# CITY OF ALBUQUERQUE

*Planning Department*  
Brennon Williams, Director

**RE: 4409 10<sup>th</sup> St. NW**  
**Grading and Drainage Plan**  
**Engineer's Stamp Date: 09/25/20**  
**Engineer's Certification Date: 03/07/21**  
**Hydrology File: G14D095**

ENGINEER'S SEAL	4409 10th Street	DRAWN BY DEM
		DATE 9-24-20
	GRADING AND DRAINAGE PLAN	4409 10TH ST. DWG
9/25/20	 <i>Rio Grande Engineering</i> 1606 CENTRAL AVENUE SUITE 201 ALBUQUERQUE, NM 87106 (505) 872-0899	SHEET #  C1
DAVID SOULE P.E. #14522		JOB #  XXXXX

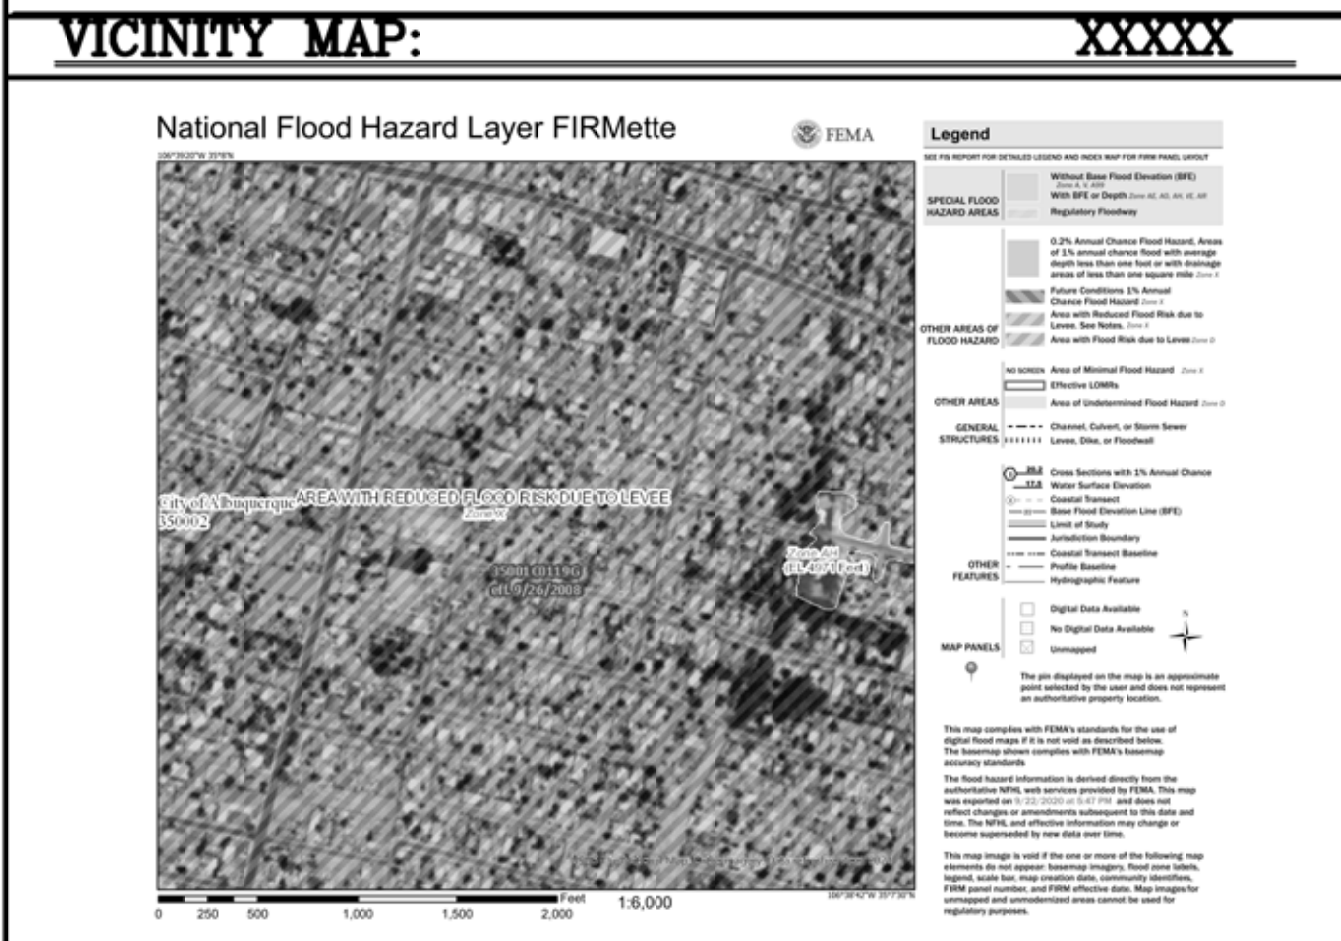
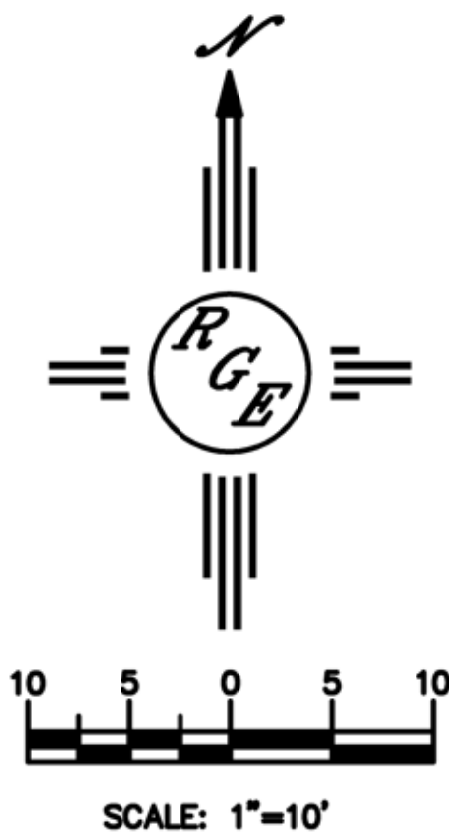
Based upon the information provided in your submittal received 03/08/2021 and site photos sent on 03/17/21, the Grading and Drainage Plan is approved for Building Permit and Building Pad Certification for 4409 10th St. NW. Please attach a copy of this approved plan in the construction sets for Building Permit processing along with a copy of this letter.

Prior to approval in support of Permanent Release of Occupancy by Hydrology, Engineer Certification per the DPM checklist will be required.
